Appln No. 09/991,199

Reply to Office action of December 1, 2003

REMARKS/ARGUMENTS

FIG. 1
PRIOR ART

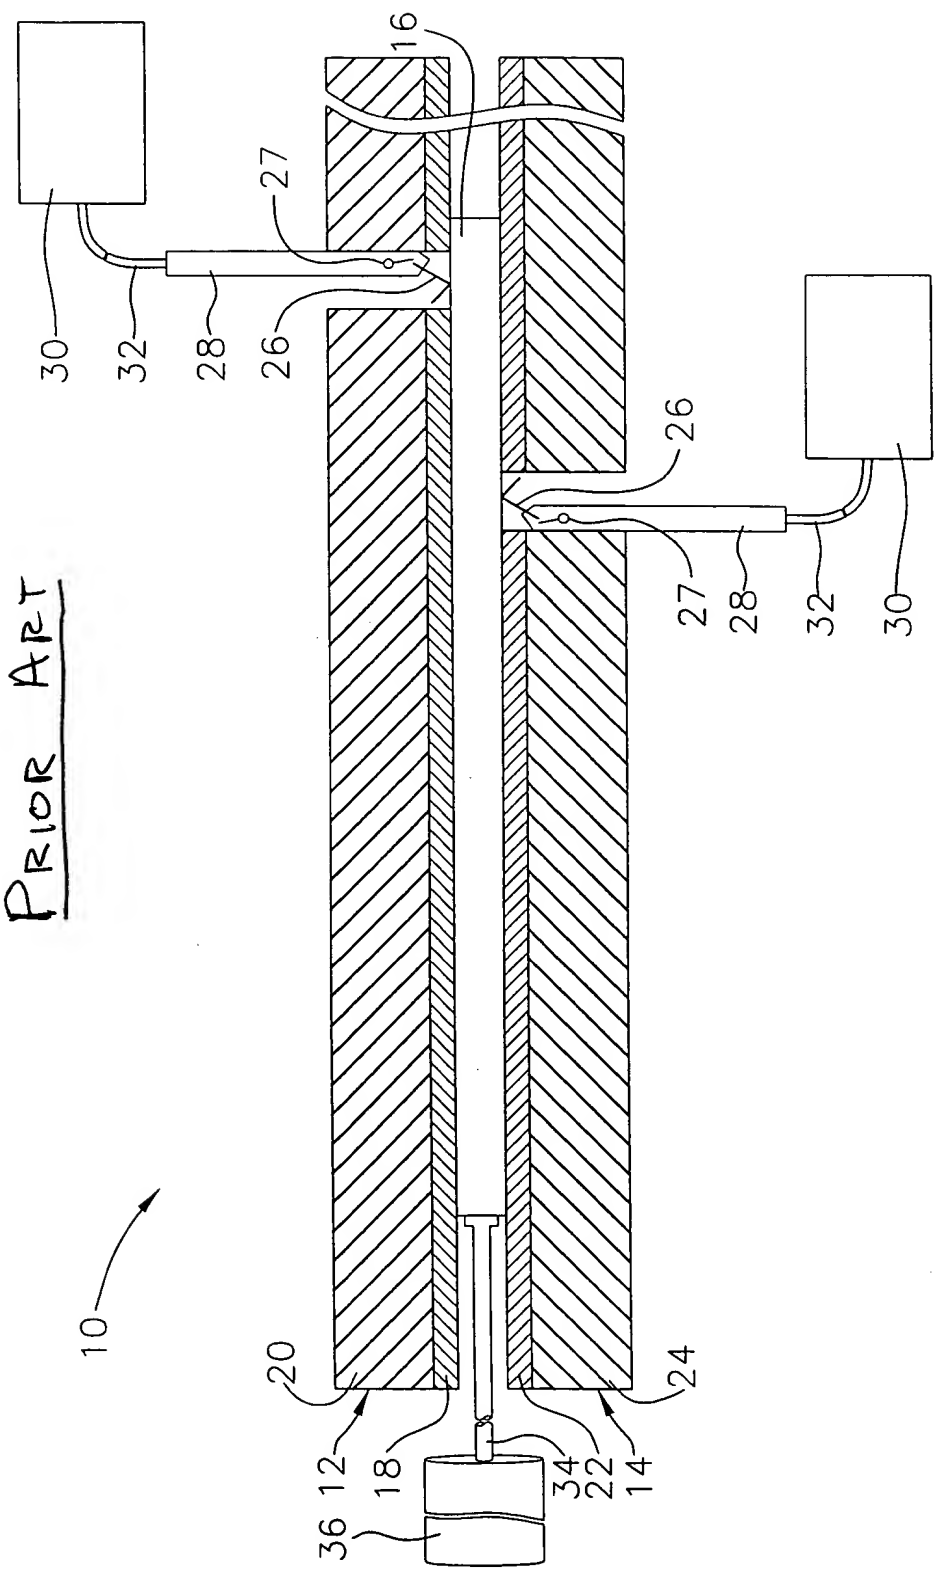
The drawings have been objected to as not showing every feature of the invention specified in the claims. The objected to claim limitations have been canceled. Figures 1-3 have been objected to as requiring a "Prior Art" legend. Enclosed please find Figures 1-3 showing the requested legend in red ink for the Examiner's approval.
